INTERIM CHANGE REQUEST

Plan Title/Rev. Unit 2 ASME Sec XI ISI Program Plan Rev 1 ICR No. ISI-2R1-01

Incorporation changes made to the RHR system
per D.M. 94-45

RESIDUAL HEAT
REMOVAL SYSTEM
SHEET 1 OF 2

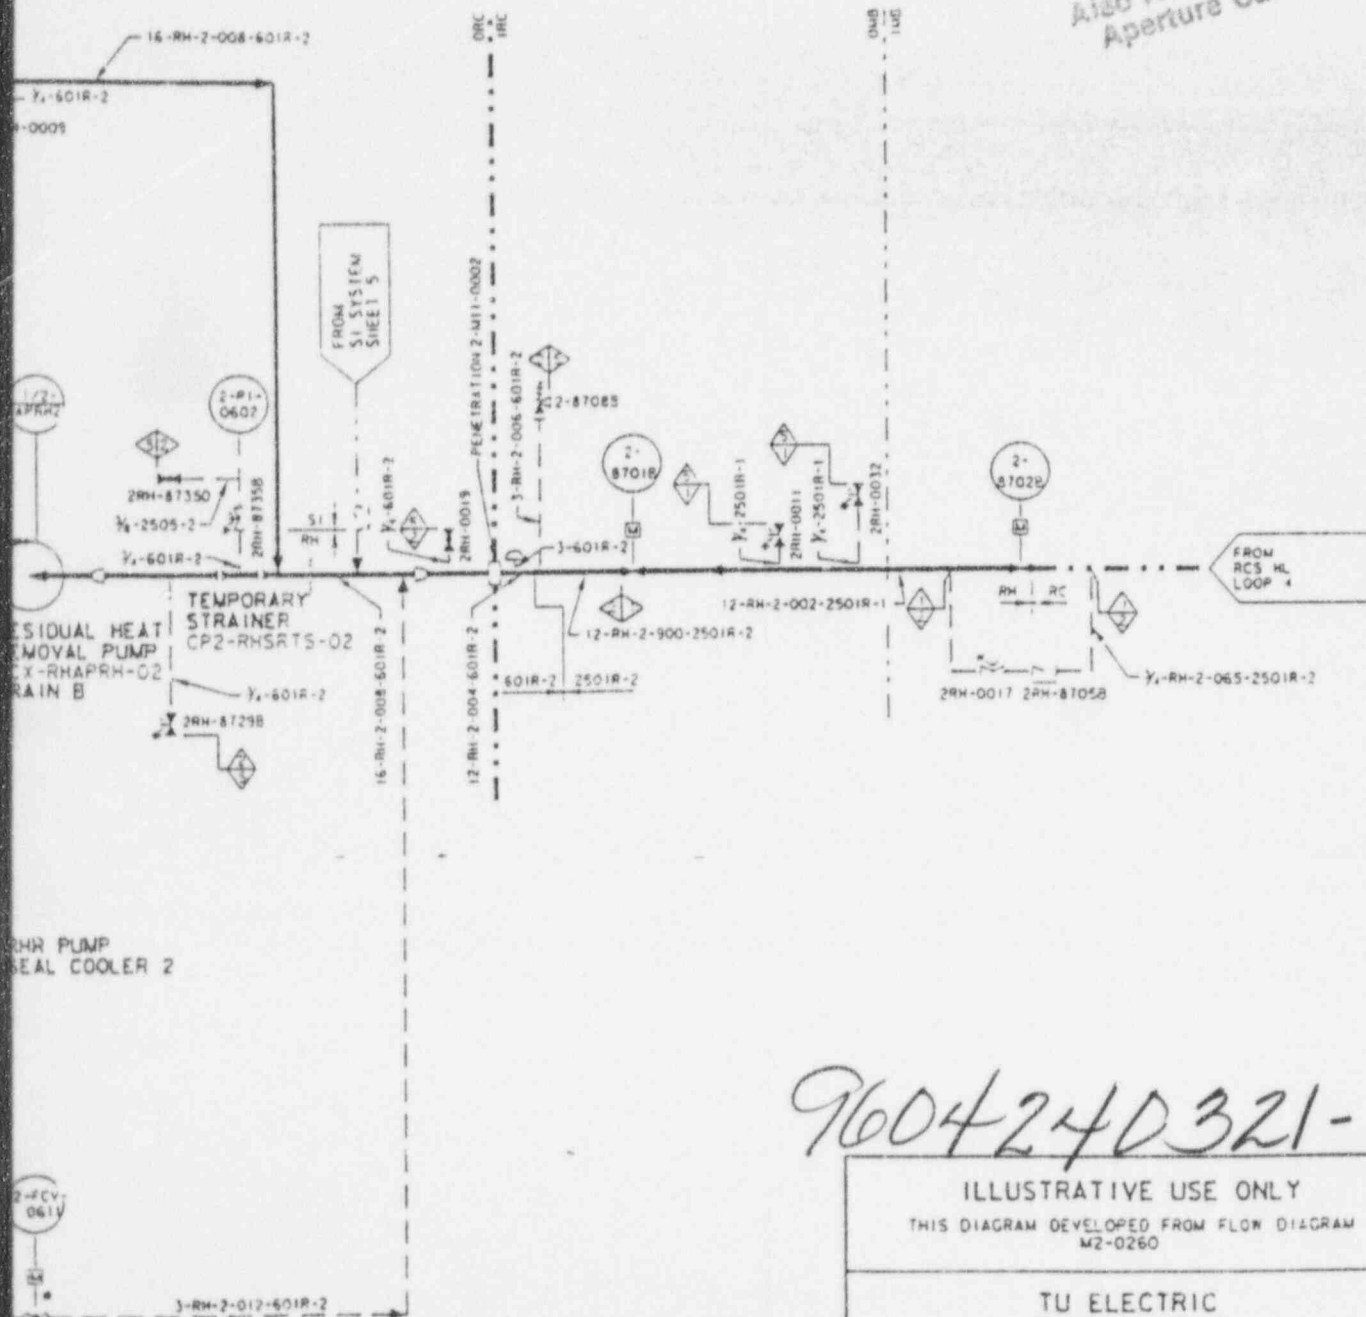
Revise boundary drawings to reflect as built condition

- Replace RHR system boundary drawings sht 1 of 2 and 2 of 2 in Section 2.0 with attached drawings
